**Re: Preliminary Site Plan Review Application; Conversion to Residential
Tax Map 1, Lot 32, 35 Badgers Island West
Response to CMA Comments**

On behalf of BIW Inc. we hereby submitted revised plans and supporting material for **Preliminary Site Plan Review Approval** to address the comments from the May 18, 2023, review letter from CMA Engineers. The review was of our April 6, 2023, submission. The Planning Board, at your April 27, 2023, meeting, voted to schedule a Public Hearing for the May 25, 2023, Planning Board. The comments were just received on May 18th. While we understand there is limited time to review our response prior to the meeting, we would like the opportunity to walk the Board through our response at the meeting. The specific comments, repeated below with our responses in bold text, are as follows:

DEMOLITION PLAN **C5**

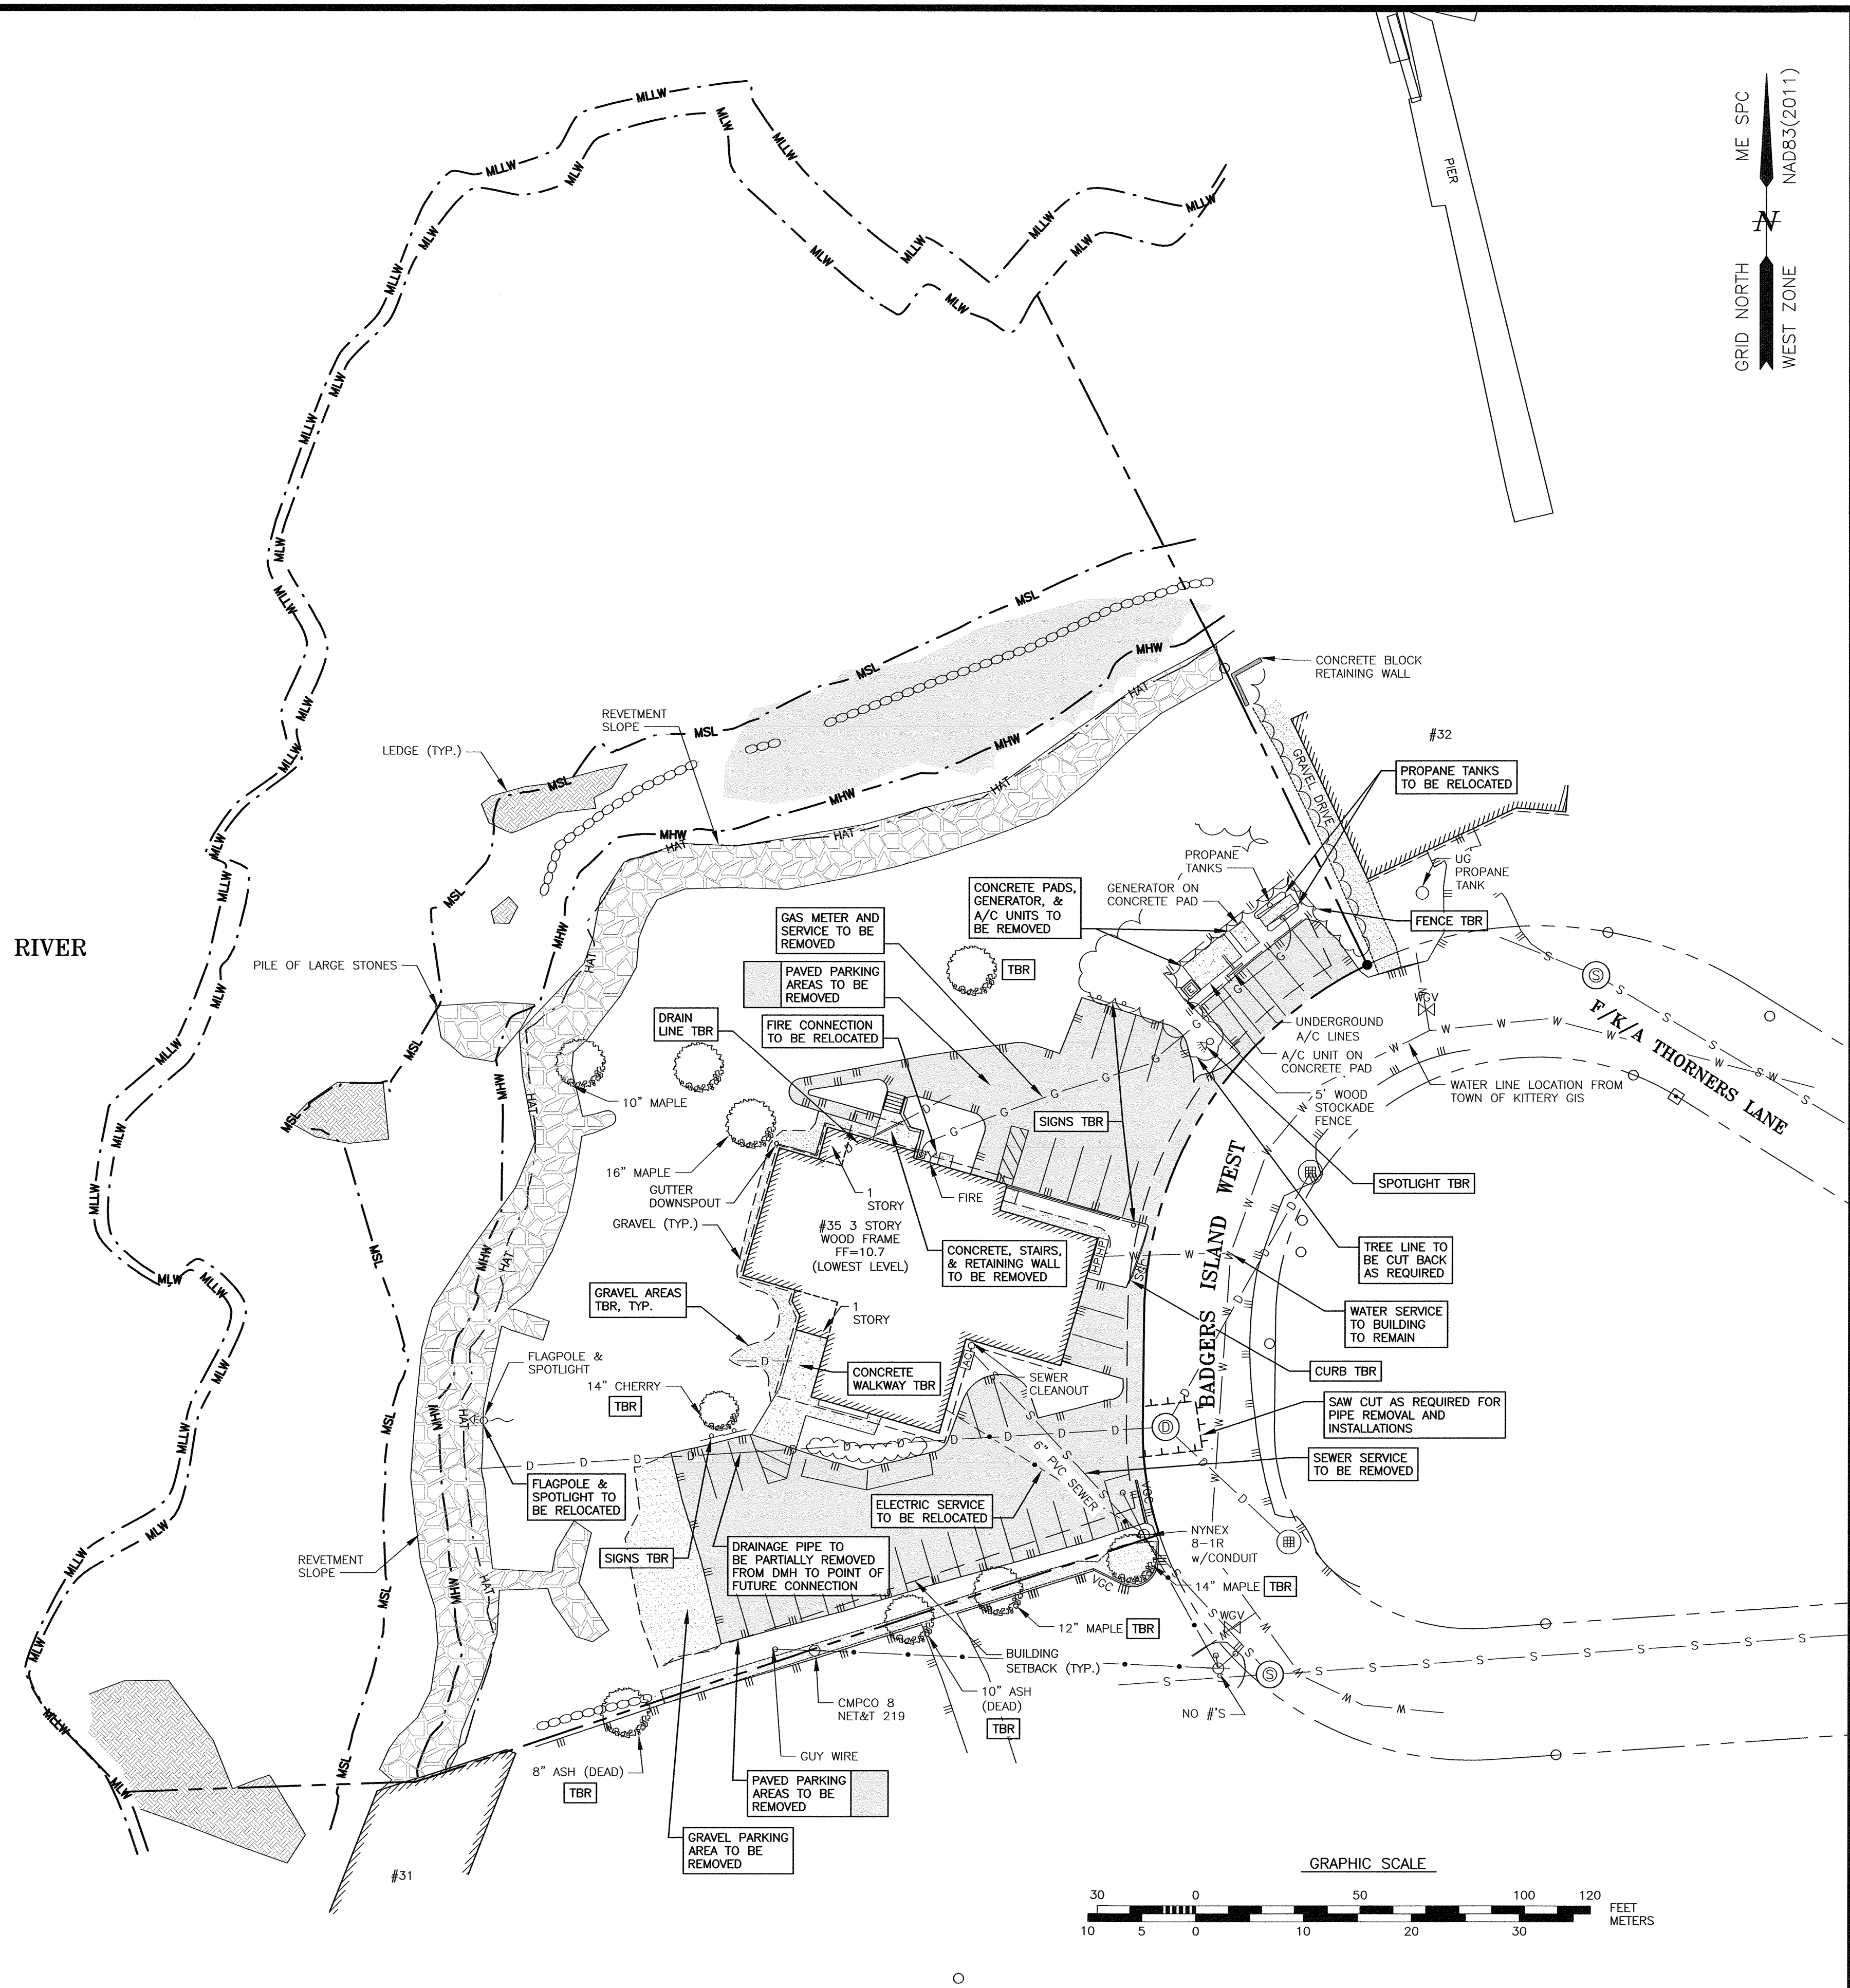
1. There is a leader indicating “Sewer Service to Remain” but Sheet C3 indicates it is to be relocated. **Noted to be REMOVED.**
2. The existing drainage pipe that is to be partially removed should be shown and called out to be removed on the plan. **Done.**
3. The plans indicate that the “Gas...Service to be Relocated” but it is not shown elsewhere on the plans. **Gas service will be eliminated.**
4. The limit of demolition should be expanded to include new pipe connection to DMH 1657. **Done.**

H TRENCH PATCH
C3 NTS

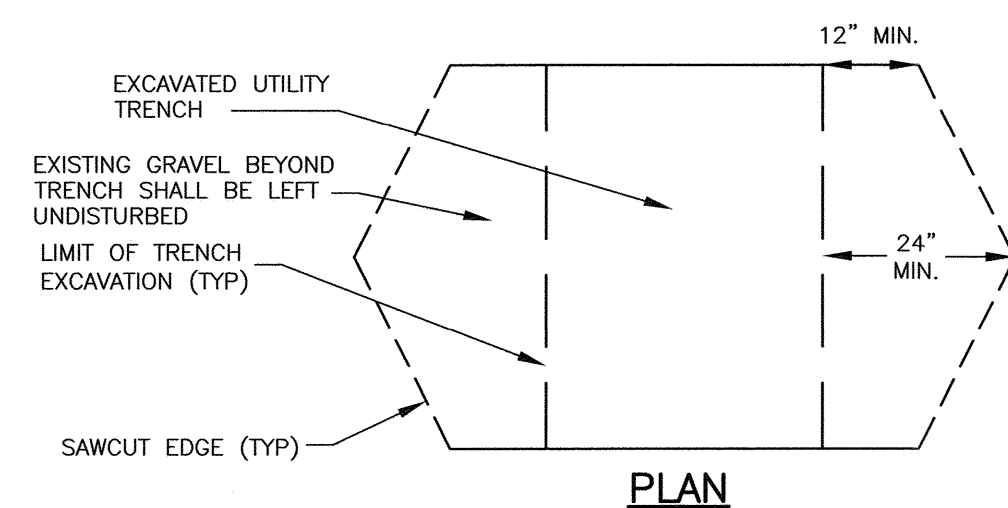
1. Provide a detail for trench patch in Badger’s Island West. **See Detail H on Sheet D3.**

JELLYFISH FILTER DETAIL

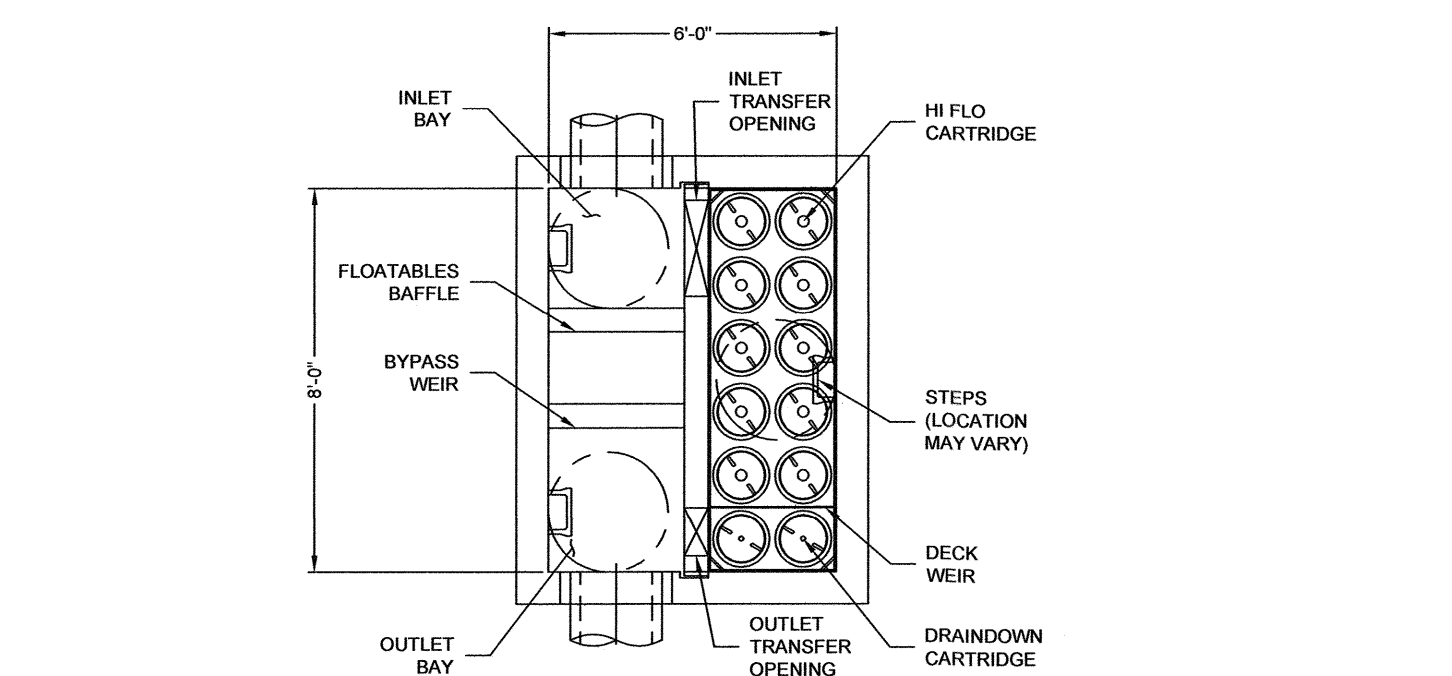
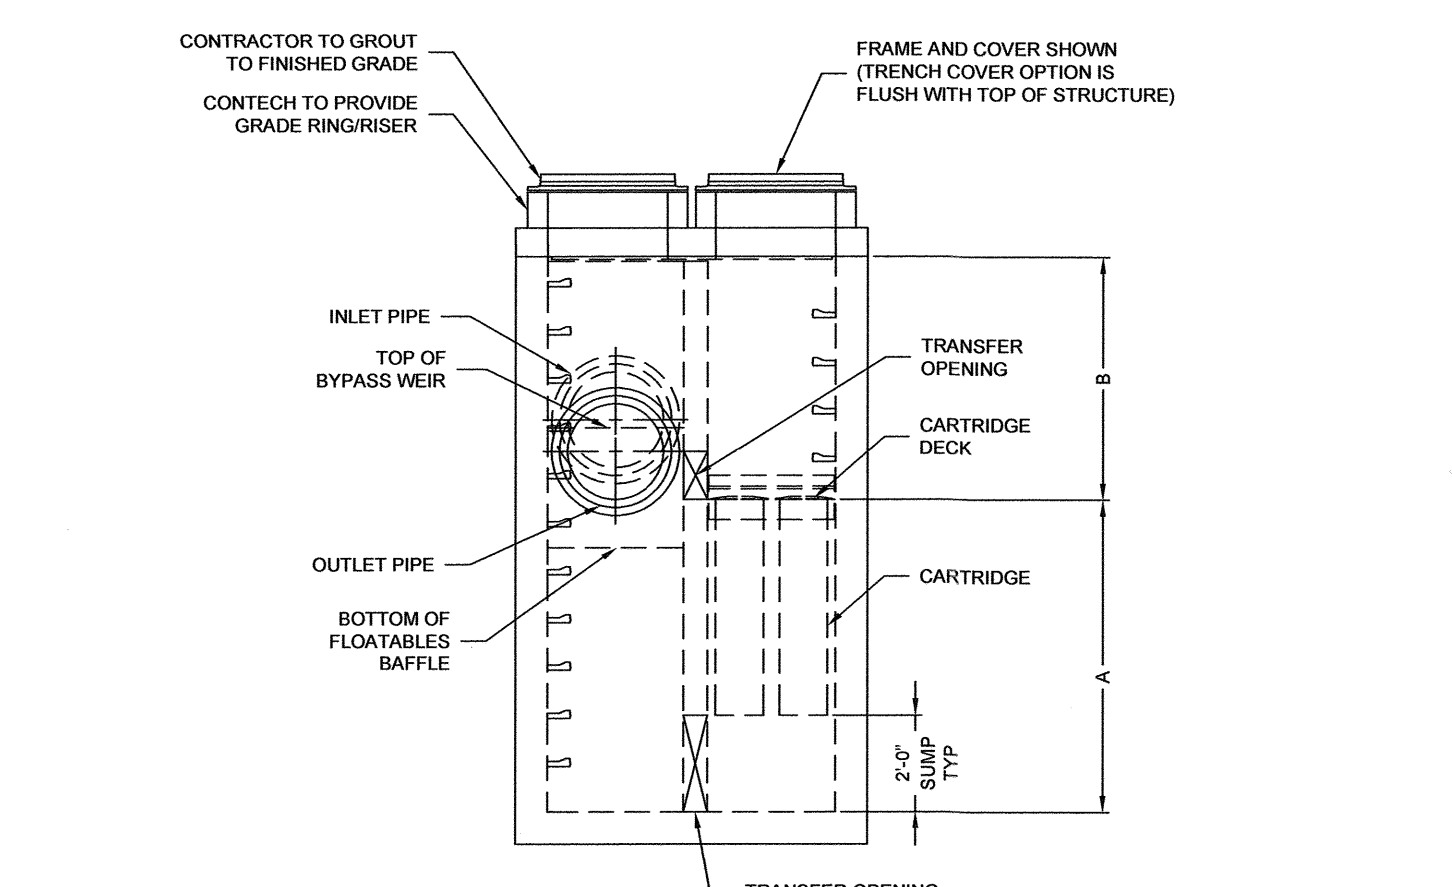
15. The Permeable Paver Long-Term Maintenance Sheet references permeable pavement. **The “pavement” wording will be replaced with “surface”.**
16. Has the jellyfish filter been designed in accordance with the specifications in the January 21, 2015, letter from Maine DEP? Are there design calculations or a project specific certification of compliance? **The specific design for this site will be provided after the layout is established.**
